NOTICE OF INTENT TO PLUG AND ABANDON

SOLOMON STATE #001Y

30-015-35738

PLUGGING PROCEDURE

Proposed PA Wellbore
SOLOMON STATE #001Y
30-015-35738-0000
Eddy

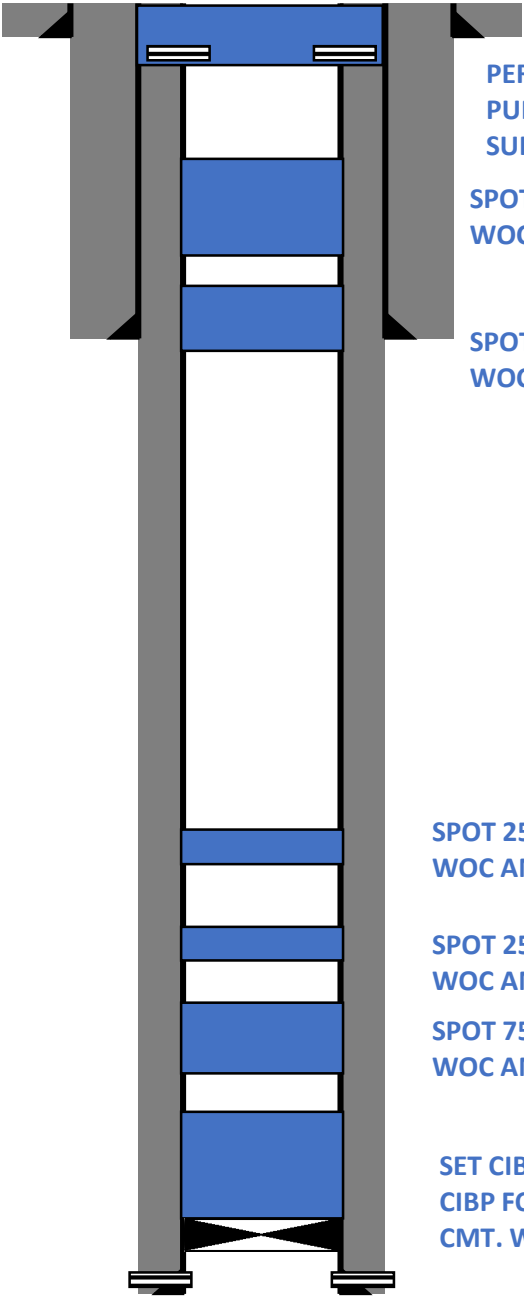
Set CIBP @ 10770' Test casing 500psi/30min - Bubble test - spot 15 sx cmt on plug. - T Atoka perforations

SPOT 25 SX CMT 9078'-8859'. WOC AND TAG. Run CBL 8200' to surface
